Determination Report

Determination of Crown Sydney Hotel Resort Barangaroo South (SSD 6957)

Figure 2: Applicant supplied image of the Foreshore Promenade

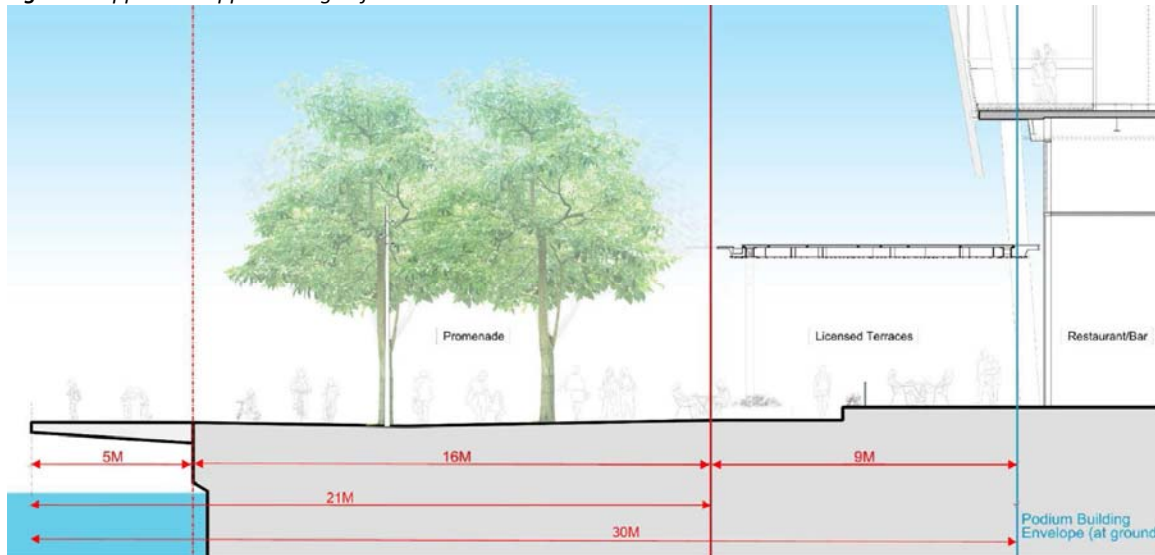
The Commission heard many concerns about the actual or perceived privatisation of public space at Barangaroo, particularly of the foreshore promenade. In operation, the 9 metre licensed area proposed will be accessible only to the paying public (with limited exceptions at building entry points), which will further extend the perception of these areas as private land rather than of the public realm. The potential scale and anticipated design character proposed for Crown Sydney in proximity of the foreshore was such that the promenade could have been read as a forecourt to the building rather than as public realm.

To secure and protect a 30 metre unencumbered promenade area on the western perimeter of Block Y, the Commission provided the following advice to the Minister regarding SEPP amendments:

The Minister agreed with the Commission’s recommendation and the SEPP was made accordingly. The Commission is comfortable that the amended Concept Plan, which provides a continuous 30 metre promenade (requiring an additional 9 to 14 metres to the promenade for the length of the Crown Sydney development) will compensate for the 9 metres dedicated to the active licensed area.

Figure 3: Extract from Applicant’s Context Plan highlighting the extent of basement level works (outlined in green). Blue line is application site boundary. Green dotted line is extent of the basement level works. Red dotted line is extent of ground level licensed area.

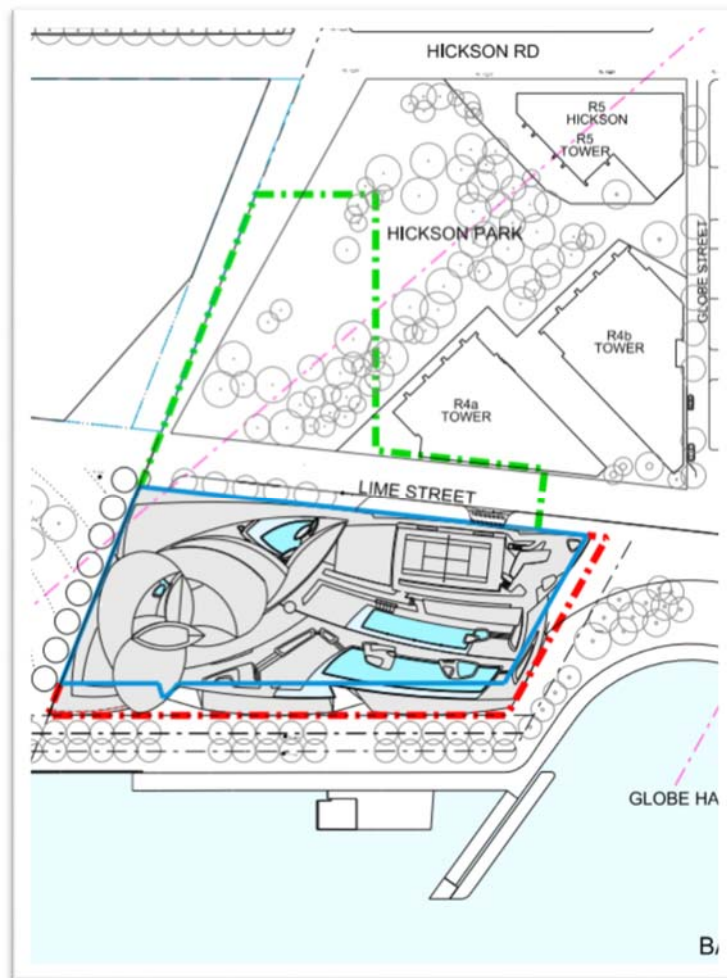
The Commission notes that the Crown Sydney development includes basement level car parking beneath Hickson Park that will potentially restrict deep soil planting in Hickson Park. The Commission considered the Apartment Design Guidelines requirement that sites greater than 1,500 sqm, have a minimum of 7% of the site provided for deep soil zone(s), with alternate planting solutions acceptable in cases of 100% site coverage. In this instance the Department accepted the Applicant’s argument that the lack of deep soil on the site is acceptable given its location, the presence of surrounding street trees, that the ground floor uses are non-residential and that onsite stormwater retention would mitigate hydrological impacts.

Although the Commission accepts that Crown Sydney cannot practically provide deep soil planting within its Block Y site, the Commission is concerned that the basement car park siting and design could

result in an adverse loss of capacity for deep soil planting in Hickson Park. The Commission acknowledges the recommendation made by the Barangaroo Design Advisory Panel that *“in all instances planting beds must be adequate to support mature large scale trees for precinct amenity. This is of particular importance for areas located above basement parking”*. In addition to the requirements of the Concept Plan, for dedicated areas of deep soil to be provided within Hickson Park, the Commission has also included the following condition in this consent, to ensure adequate deep soil planting can be accommodated above the basement intrusion under Hickson Park.

- B10 Prior to the issue of any Construction Certificate for basement parking, a detailed Hickson Park Landscape Plan must be approved by the Secretary. The Plan must:
- be prepared in consultation with Council and the Barangaroo Delivery Authority;
 - be reviewed by an independent arborist to confirm that the proposed tree plantings and soil depths will support long-term viable stands of medium to tall trees (to a height of at least 15m, with well-formed canopies);
 - demonstrate that the park will predominantly comprise soft landscaping, extensive areas of grass and stands of large trees; and,
 - map the location of the 3 m deep soil zones to be provided over 2,000 sqm of Hickson Park, required by the Concept Plan.

Figure 4: Elevation depiction of proposed signage

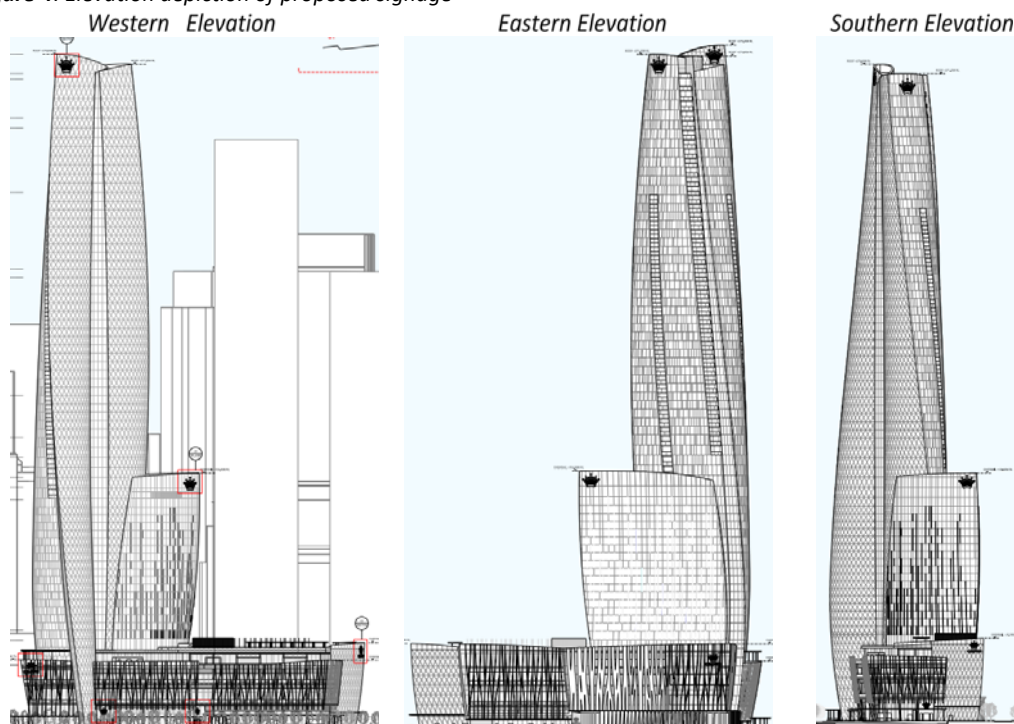
The Commission heard concerns regarding the potential for the proposed branding to impact on the Sydney skyline. The Barangaroo Design Advisory Panel stated that *“signage to the upper levels of the building (above podium level) is inappropriate and unnecessary as the intended iconic nature of the building will ensure that it acts as its own sign”*. The Applicant has advised the Commission that branding is critical to their function and that they believe it would be discriminatory to not allow any signage on the Crown Sydney building including the tower. The Barangaroo Delivery Authority also confirmed with the Commission that they supported the proposed branding and were comfortable that it had been designed as integral to the architecture.

B11 Prior to the issue of the relevant Construction Certificate the Applicant shall submit amended podium signage plans for the Secretary’s approval demonstrating:

- (a) Drawing No 00915-11-SK-1719, West Elevation, sign no. 1, shall comprise the Crown logo only with the word ‘Crown’ removed;
- (b) Drawing No 00915-11-SK-1719, West Elevation, the two ground level signs to be removed;
- (c) Drawing No 00915-11-SK-1722, South Elevation, the ground level sign to be removed; and,
- (d) Drawing No 00915-11-SK-1722, South Elevation, sign no. 3, shall comprise the Crown logo only with the word ‘Crown’ removed.

Figure 5: Wind Mitigation Measures including trees, glass blades, canopies and deployable shades

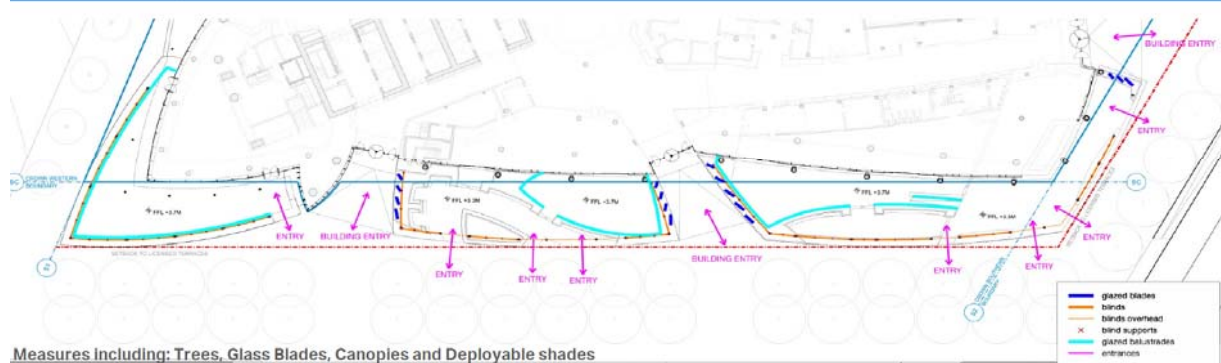
Concerns were raised at the public meeting that the Crown Sydney development would potentially create wind tunnels with some spots only safe to walk in for able-bodied persons. The Applicant in meeting with the Commission outlined a number of design measures they had adopted in order to combat potential wind impacts, the below **Figure 5** demonstrates these measures.

The Department, in its assessment, evaluated the Wind Impact Assessment (WIA) prepared by the Applicant. The main issue raised within the Department's assessment related to tree planting within the Central Parklands, albeit recognising that the landscape strategy for Central Parklands is not yet known. The Department noted that the Applicant's Wind Impact Assessment highlighted that negative wind conditions can be suitably mitigated through the provision of wind planting along the waterfront promenade. The Department's report concluded that sufficient wind mitigation measures were included by the Applicant and that no public access to wind affected areas (Barangaroo Central) would occur until the area was appropriately landscaped.

The Commission is satisfied that the wind impacts created by the Crown Sydney building are able to be managed, however the Commission acknowledges that the Applicant does rely on promenade planting in its assessment and as such has required that the foreshore promenade be fully landscaped and completed prior to the occupation of the Crown Sydney building.
